# TECHNICAL BULLETIN

## INTRAAAX AA250 TRAILER AIR SUSPENSION AXLE RESTRAINING SYSTEM

**No:** TRAILER AUS-010  
**Subject:** Improvement  
**Date:** August 1998 **Revision:** A

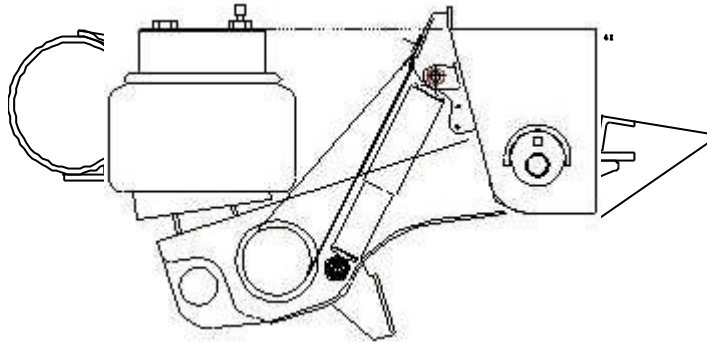
*As part of our continuous improvement program, Hendrickson have released an Intraax AA250 axle restraining system (98918-002) to alleviate isolated reported concerns. Also refer bulletin AUS-007*

Part number 98918-002 consists of;  
2 x Brackets      2 x Restraint Straps  
2 x Bolts          2 x Lock nuts  
4 x Washers      1 x Instructions

*If the suspension operation is such that the axle is lifted off the ground in a tip-over axle application, Hendrickson recommend the restraint kit be installed.*
